CALIFORNIA COASTAL COMMISSION

STAFF REPORT: CONSENT CALENDAR

APPLICATION NO.: 5-97-078

PROJECT DESCRIPTION: Demolition of an existing 1,300 square foot single family residence, and construction of a three-story, 29 foot high (with 37 foot high roof access structure), 3,674 square foot single family residence with an attached three-car garage.

EXHIBIT # 4

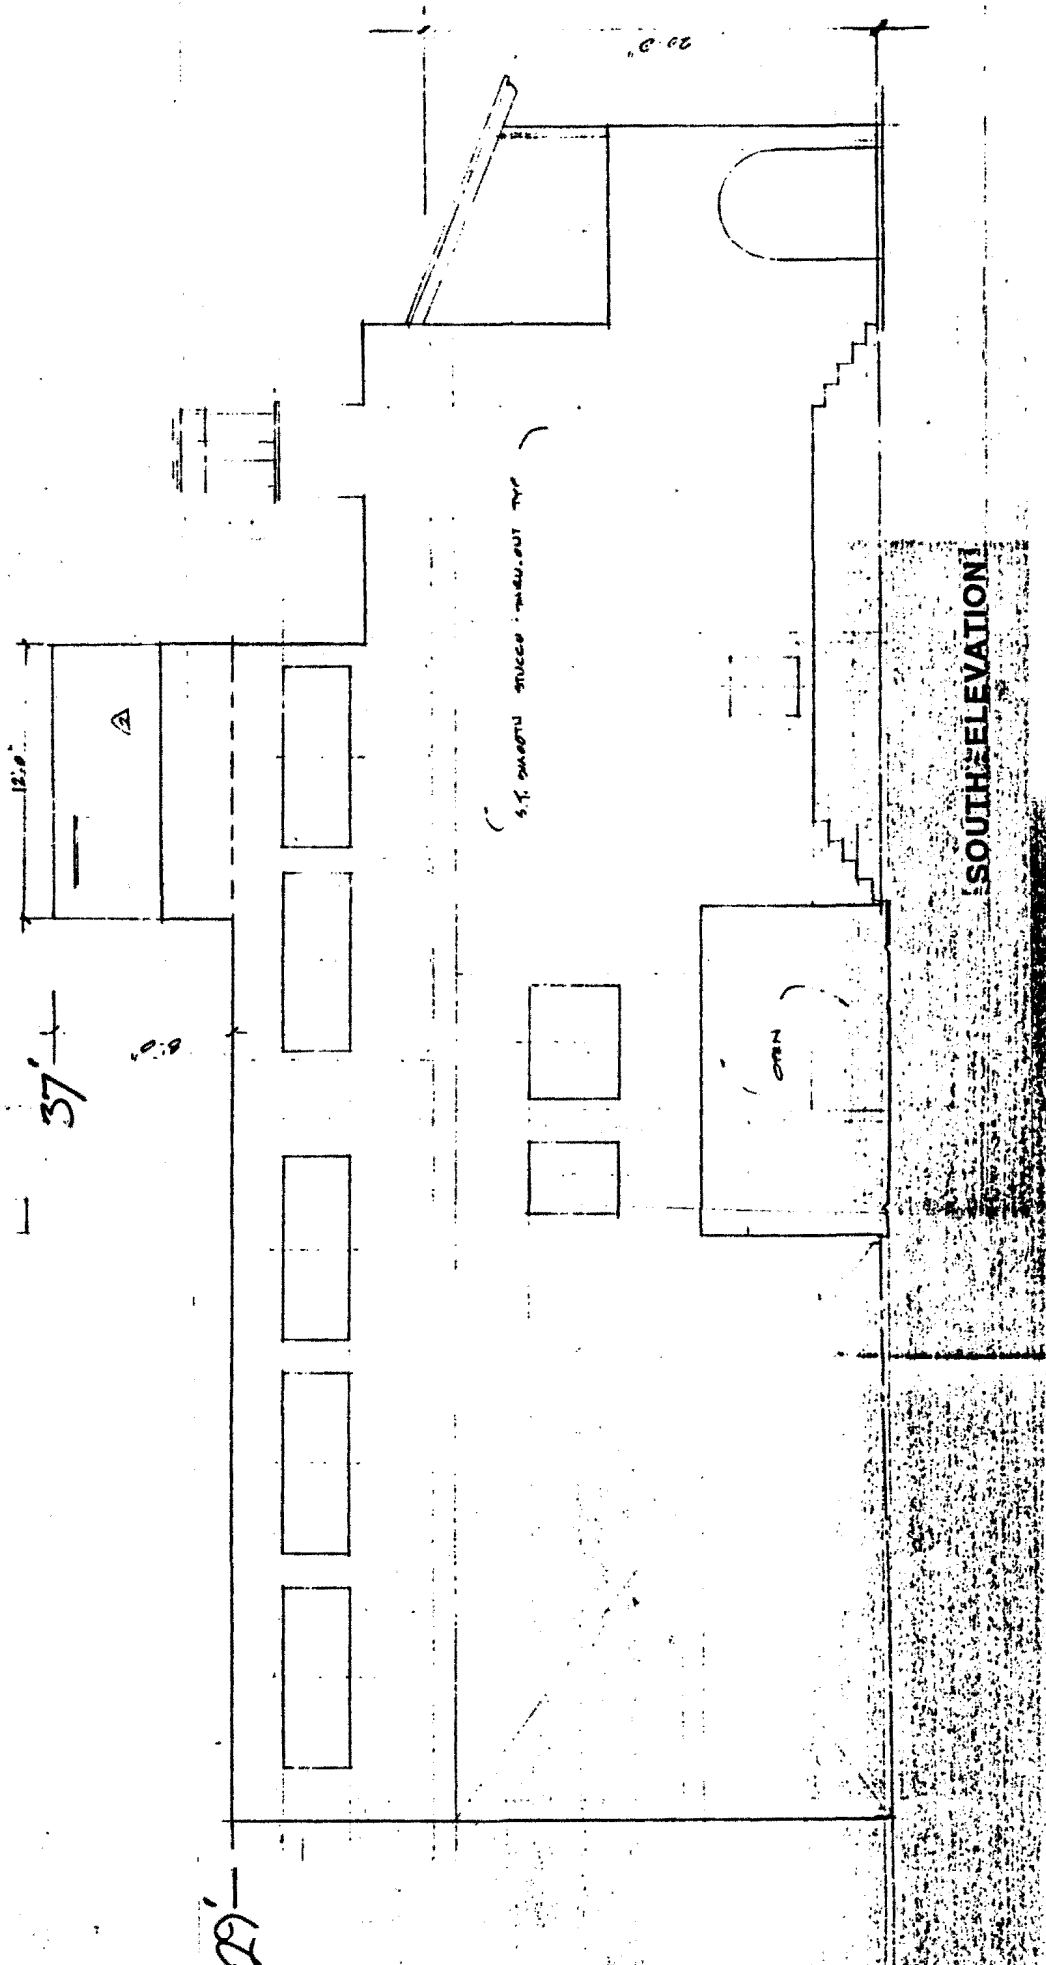
In this case, the proposed structure is set back fifteen feet from the canal property line (Exhibit #4). The proposed project, with its fifteen foot front yard setback and 450 square feet of pervious yard area, conforms to the Commission's front yard setback requirement. As required, no fill or building extensions are proposed to be placed in or over the required pervious front yard area. However, an uncovered permeable deck may be constructed in the front yard area.

To mitigate this problem, the Commission has consistently conditioned new development within the canals to provide a rear setback of at least nine feet for guest parking or to make other provisions for guest parking. The required rear setback for guest parking is in addition to the Commission's other parking standards. In this case, the proposed project provides three on-site parking spaces in an attached three-car garage (Exhibit #4).

In order to provide a setback for access, visual quality, and to protect the water quality and biological productivity of the canals, an uncovered and pervious yard area totaling no less than 450 square feet shall be maintained in the front yard area between the front of the structure and the front (canal) property line. No fill or building extensions shall be placed in or over the 450 square foot pervious front yard area with the exception of fences or permeable decks at grade. Fences in front yard areas shall not exceed 42 inches in height.

A minimum of three parking spaces shall be provided and maintained on the site.

EXHIBIT # 5

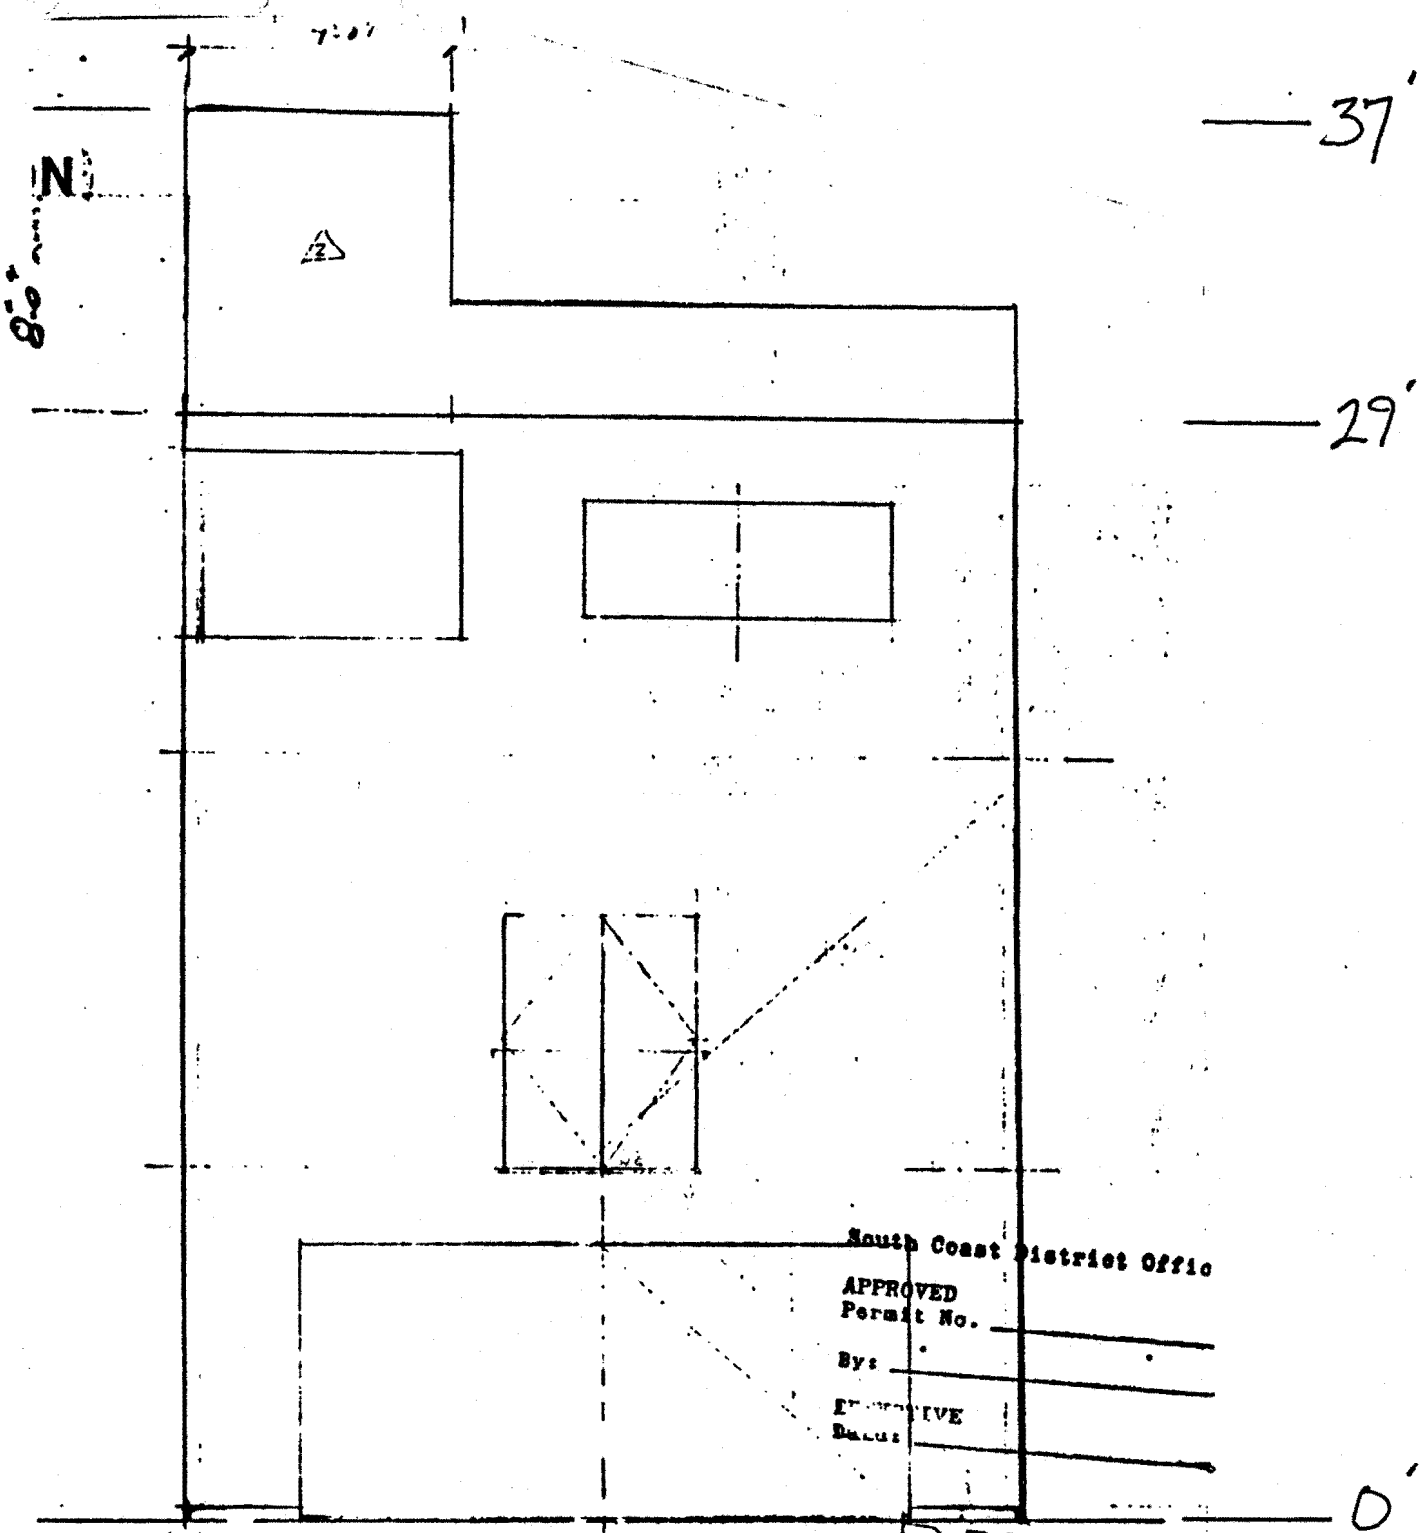
In this case, the proposed project has a roof height of 29 feet. However, a proposed 84 square foot roof access structure is proposed on the roof to provide access to the roof deck. The proposed roof access structure is 37 feet high, eight feet above the roof elevation (Exhibit #5). Roof access structures have previously been permitted to exceed the thirty foot height limit if they are designed to be the minimum size necessary to provide roof access and if they do not negatively impact the visual resources of the area. In addition, roof access structures may not contain any living or storage space. Chimneys, skylights, and some roof equipment may also be permitted to exceed the thirty foot height limit if there is no impact on the area's visual resources. In this case, the Commission finds that the proposed 37 foot high roof access structure is designed to be the minimum size necessary, does not contain any living or storage space, and does not negatively impact the visual resources of the area. Therefore, the proposed project conforms to the Commission's height requirements.

The height of the structure shall not exceed thirty feet above the centerline of the canal walkway (with the exception of an 84 square foot, 37 foot high roof access structure).
